# STAFF CASE REPORT TO PLANNING COMMISSION

<b>Subdivision Case Number:</b>	<b>2016-015</b>	<b>PC Meeting Date:</b> 03-14-16
<b>Subdivision Name:</b>	<b>Grays Addition to Jenkins Road                  Lots 1A and 1B                  Variance Request-Minimum                  Suburban Infill Lot Frontage</b>	
<b>Applicant Request:</b>	Variance-Section 38-44 of the Chattanooga Zoning Regulations (7) Minimum Suburban Infill Lot Frontage	
<b>Property Location:</b>	1700 Jenkins Road	
<b>Property Owner:</b>	Churchview Properties	
<b>Applicant:</b>	Churchview Properties	
<b>Total Acreage:</b>	0.39 Acres	
<b>Proposed Density:</b>	5.12 Dwelling Units Per Acre	
<b>Tax Map Number:</b>	159J-A-014	
<b>Zoning:</b>	R-1 Residential Zone	
<b>Staff Recommendation:</b>	<b>DENY</b>

REVISED PLAT  
 LOTS 1-A & 1-B  
 Grays Add. East Brainerd  
 City of Chatt., Hamilton County, Tennessee

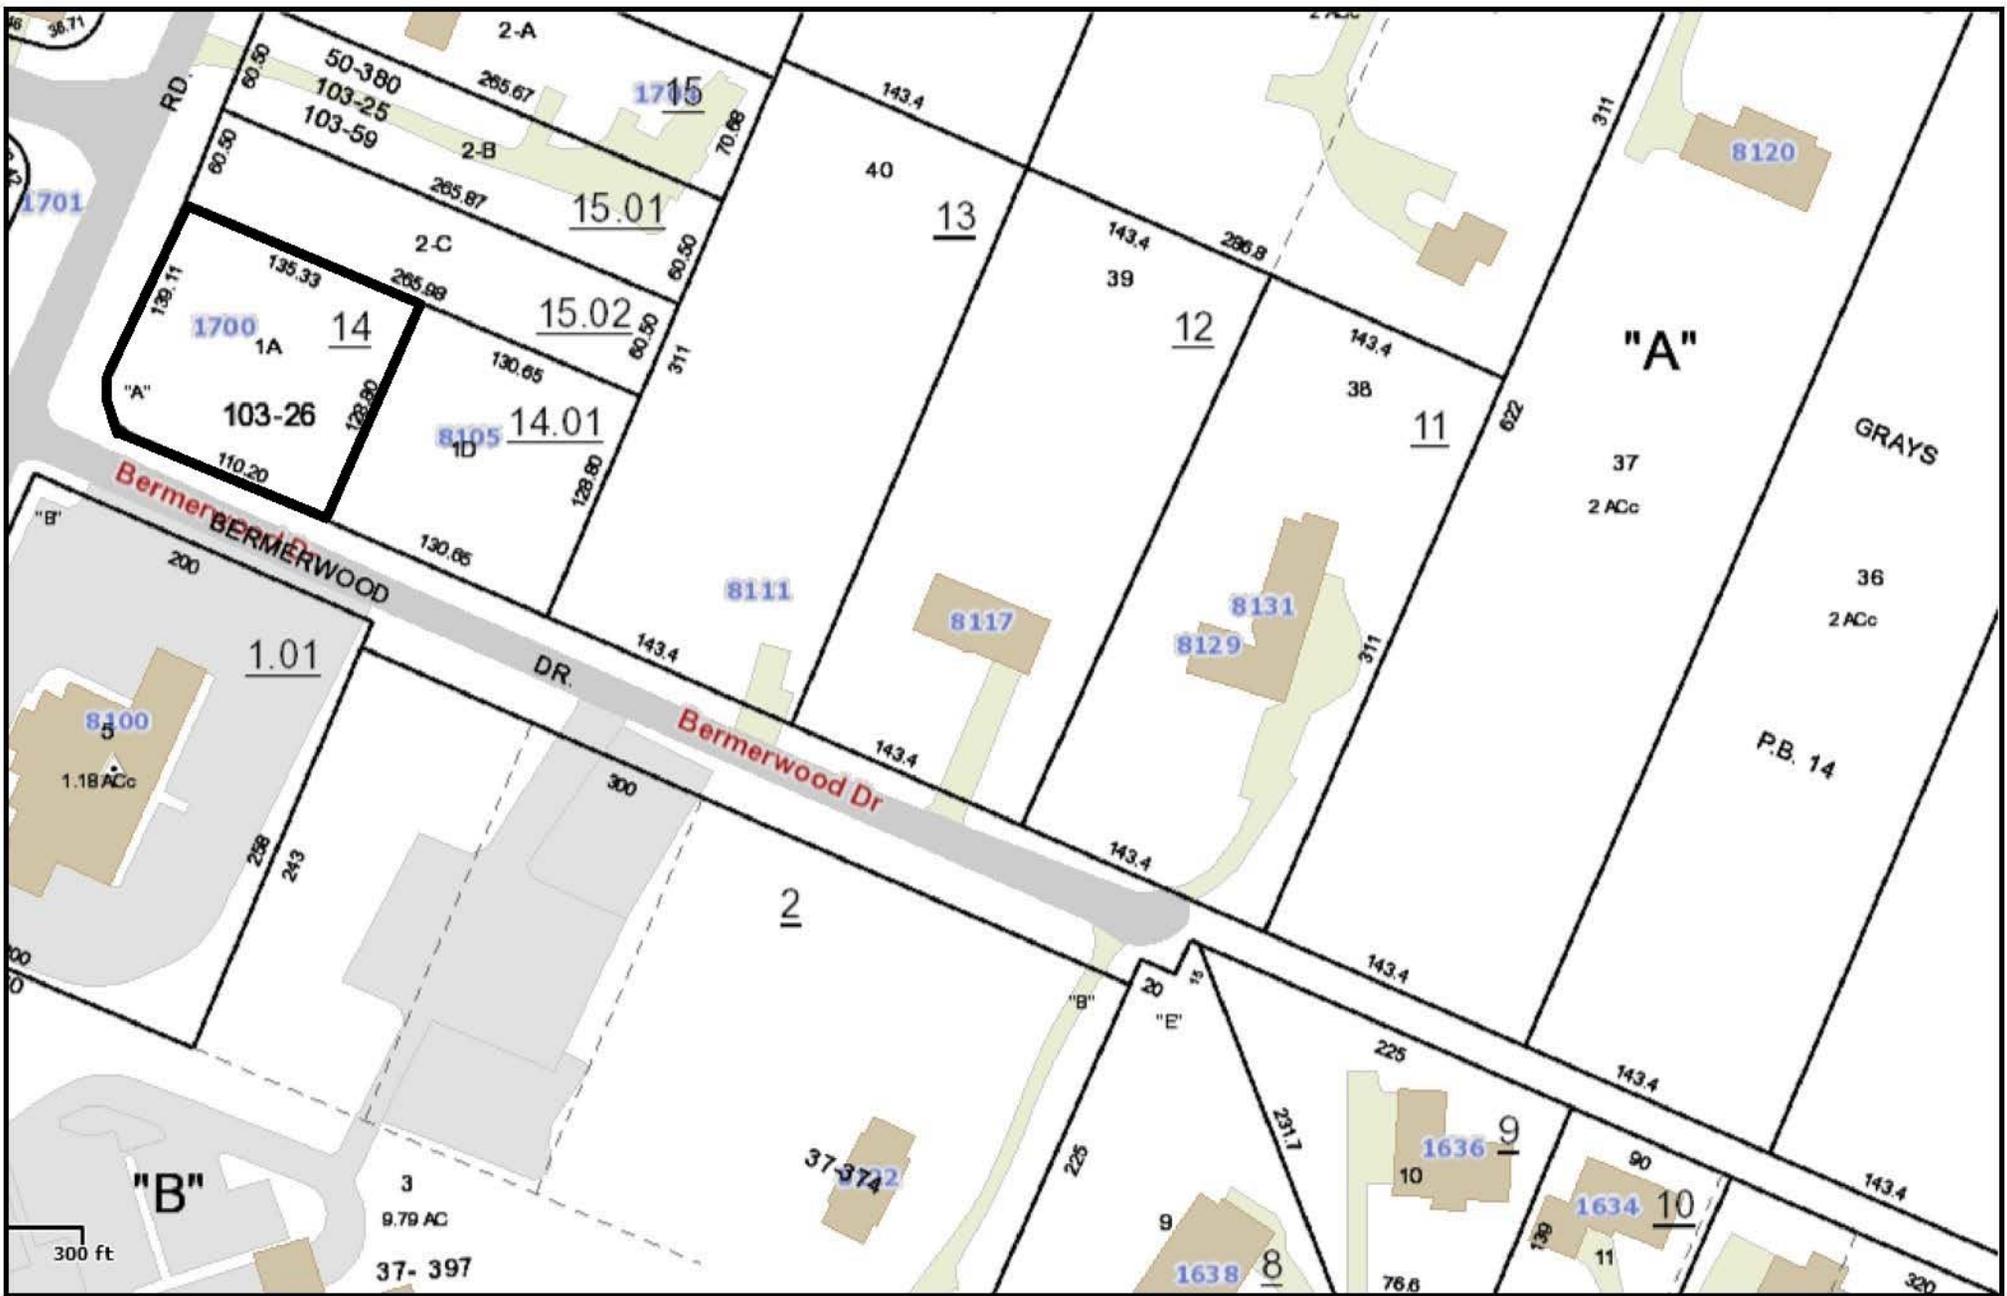
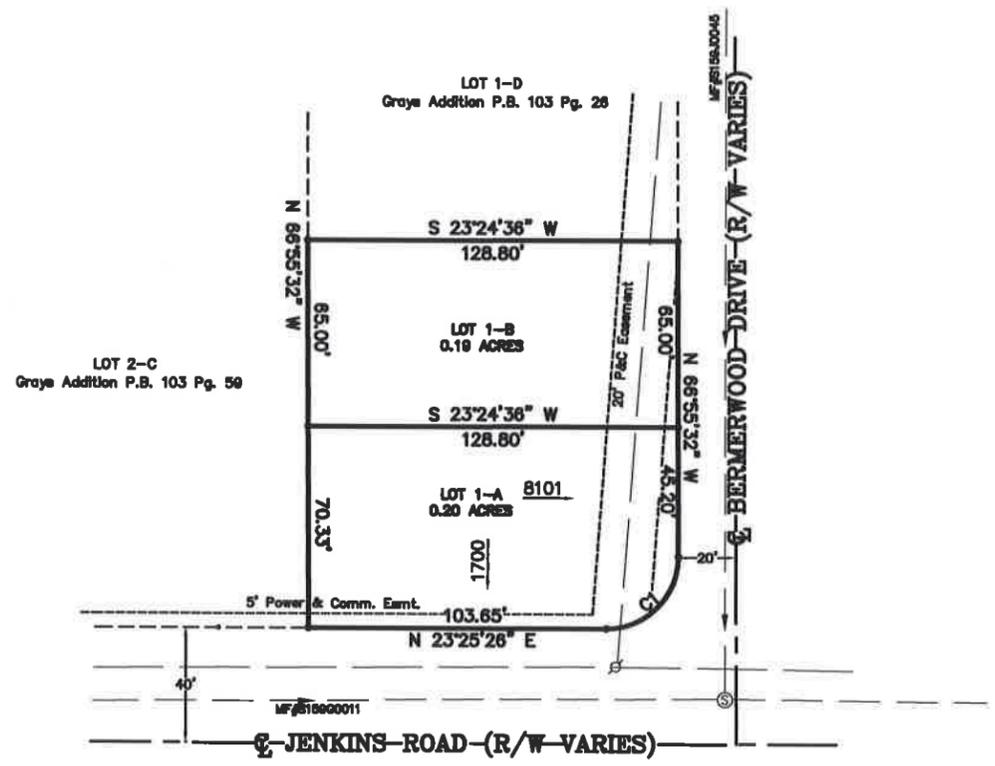
The applicant is requesting a variance to permit proposed Lots 1A and 1B to have a lot frontage along Bermerwood Drive that is less than the required minimum of 120' along Bermerwood Drive.

**Lot 1A: 70.35' (Variance of 49.65')**

**Lot 1B: 65' (Variance of 55')**

Staff recommends to deny the applicant's request for the variance.

- There is no physical condition or hardship present other than a self imposed hardship of a desire to create the potential for two new additional lots along Bermerwood Drive.

- Approving the variance would be in conflict with the intent and purpose of the Chattanooga Subdivision Regulations and the Chattanooga Zoning Regulations.
- The intent of the suburban infill lot frontage requirements is to create lots that have a lot size and lot frontage that is compatible with adjoining lots within 300' of the site being subdivided.

- Approving the variance would be detrimental to the public interest in that lots for residential purposes would be created along the northern side of Bermerwood Drive that would not be compatible the adjoining lots on the same side of Bermerwood Drive.
  - If approved, these lot frontages would set the minimum lot frontage for future or similar requests to subdivide existing property along Bermerwood Drive.
  - Approving the variance request would create a situation that does not now currently exist along Bermwood Drive.
  - Approving the variance request would create dissimilar or incompatible lots along Bermerwood Drive.
-
